FLYING HORSE NORTH FILING NO. 7
CONSTRUCTION DRAWINGS

FLYING HORSE NORTH FILING 7
PRI #2, LLC.
EL PASO COUNTY, CO

CONSTRUCTION DOCUMENTS
COVER

DRAINAGE DETAILS
POND F1 DETAILED GRADING

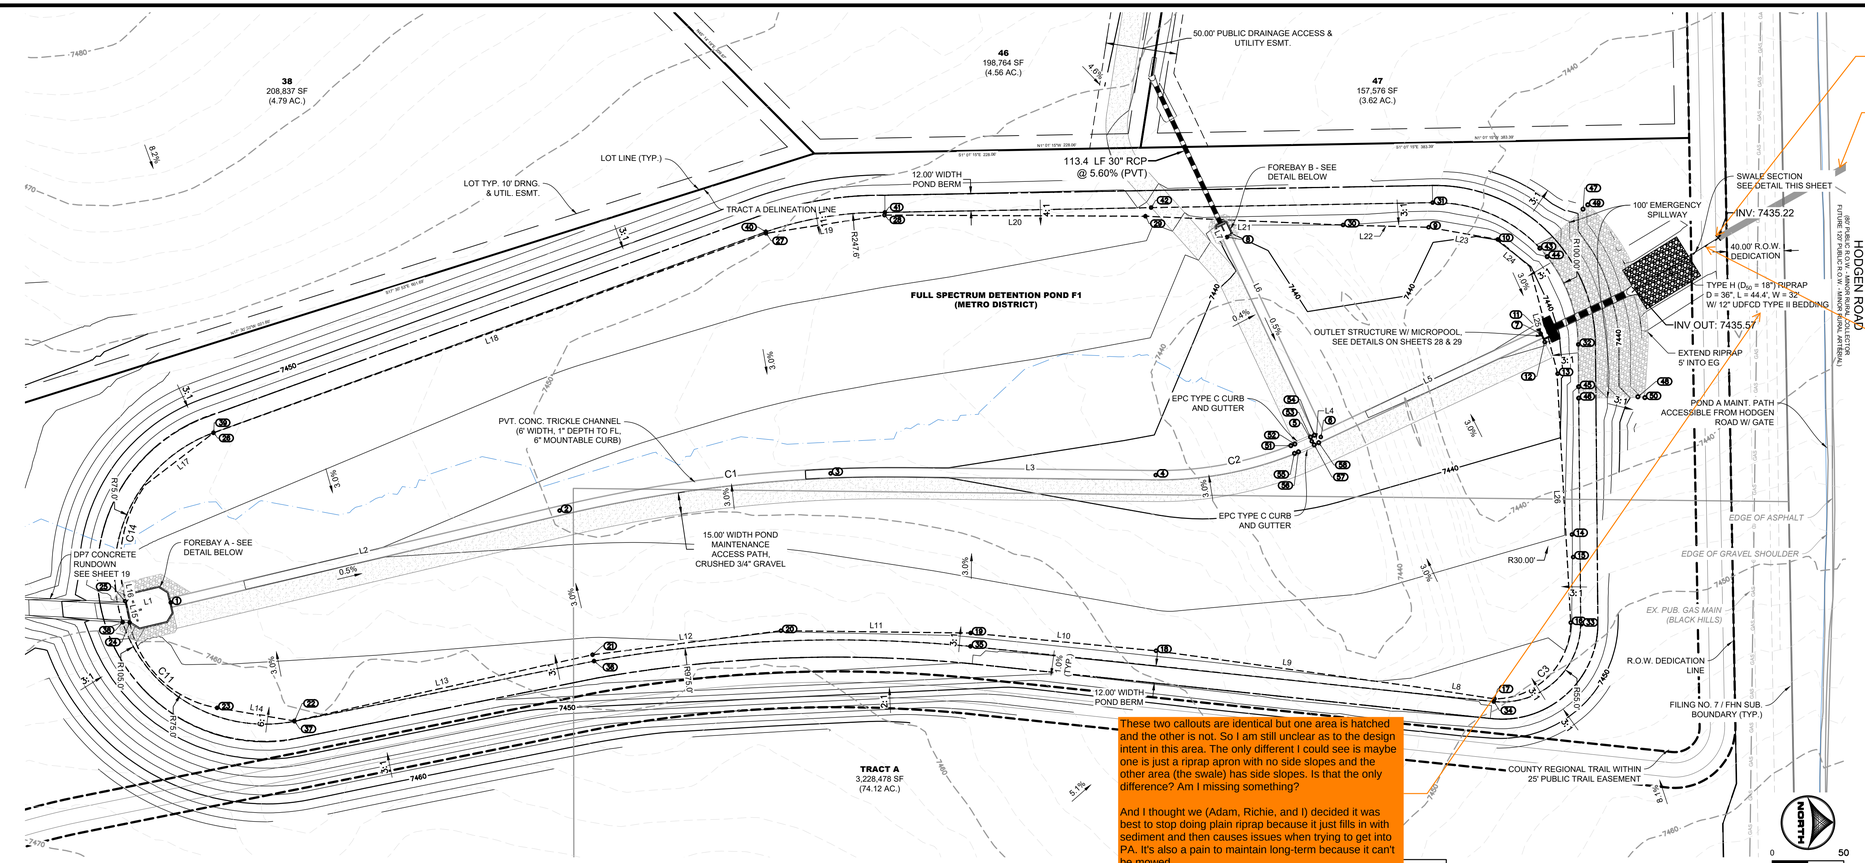
How are you planning to transition from a 32ft wide swale to a 54in pipe? I think a detail is needed for this area.

Add a label for this pipe (ex 54" culvert).

What's to keep flows from finding the path of least resistance to the toe of the side slopes and eroding them? We saw that happen at another recent FHN filing. It would be much better to give this swale some shape (V or U) to keep most flows in the center. Or you could add riprap up the side slopes, but I feel like would be less effective. You could do both though.

POND F2 OUTLET SWALE DETAIL

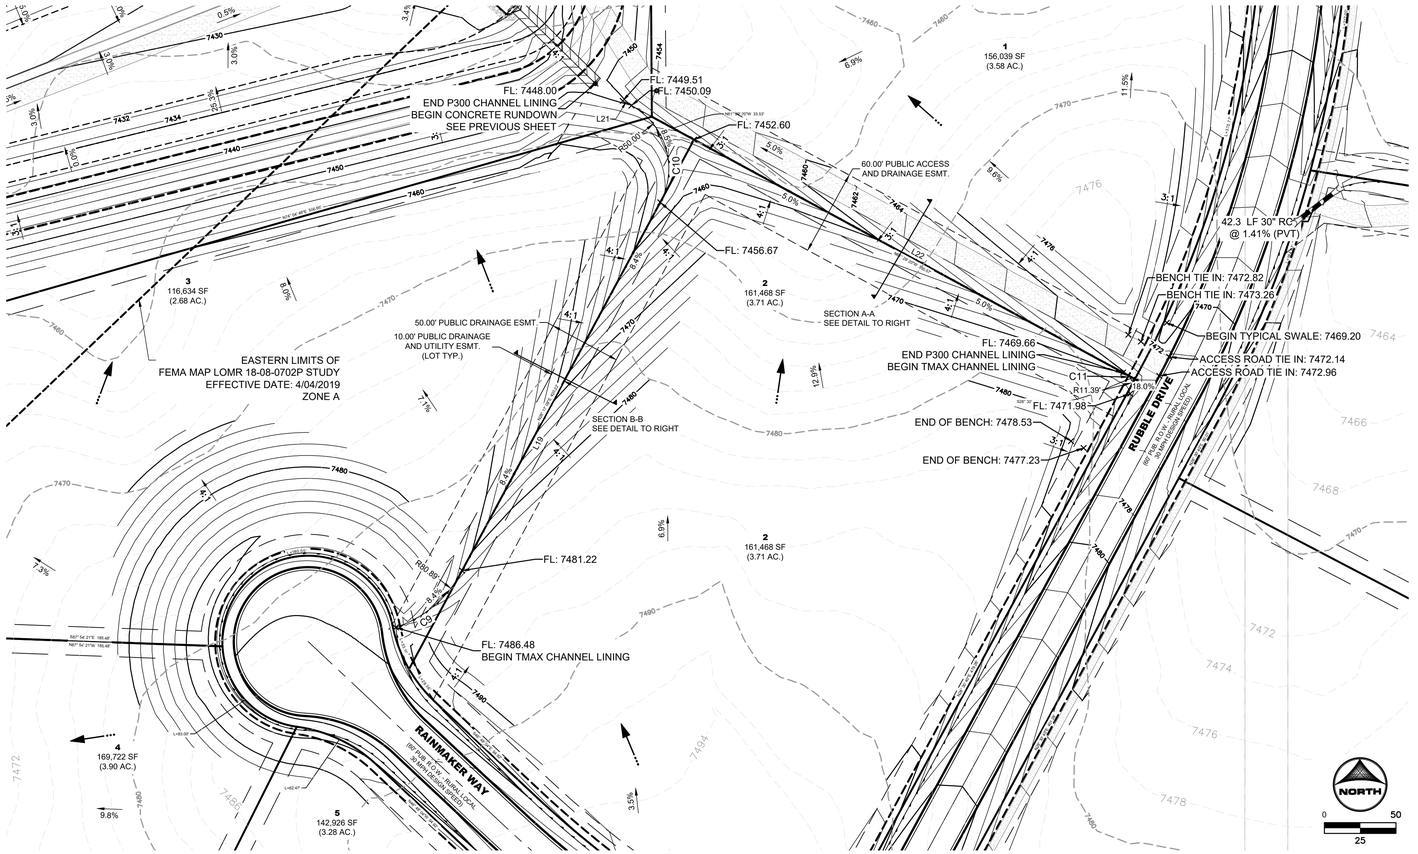
See comments on previous sheet

Unlike the swale detail on the previous sheet, here you do show riprap going up the slope a little bit, but no details or dimensions are provided.
